GROUP Body	MODEL Forte/Forte Koup
NUMBER 049	DATE October, 2009

TECHNICAL SERVICE BULLETIN

SUBJECT: SERVICE ACTION: ENGINE COMPARTMENT
JUNCTION BOX RELAY REPLACEMENT (SA012)

Location of Four Relays to be Replaced
With Part Number 95224 1M000QQK

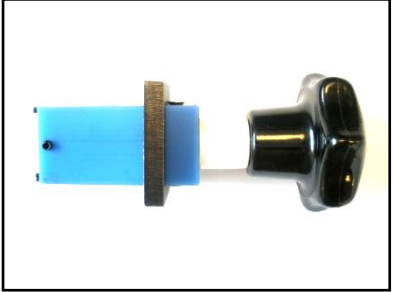
Some Forte/Forte Koup vehicles manufactured from July 16th to August 20th, 2009 may experience concerns of inoperative A/C blower, high/low cooling fans or engine start motor. The concern may be caused by poor contacts inside the four (4) relays located in the engine compartment junction box as shown below. It is recommended that all vehicles within this production range be repaired prior to retail sale to a customer. Additionally, vehicles being in for service should be checked and if necessary repaired before returned to the customer.

Part Name	Part Number	Figure
Relay Kit (Kit Consists of 4 Relays)	95224 1M000QQK (Previously 95224 1M000)	 <div style="border: 1px solid black; padding: 5px; margin-top: 5px; text-align: center;"> New Relay is Identified by White Dot </div>
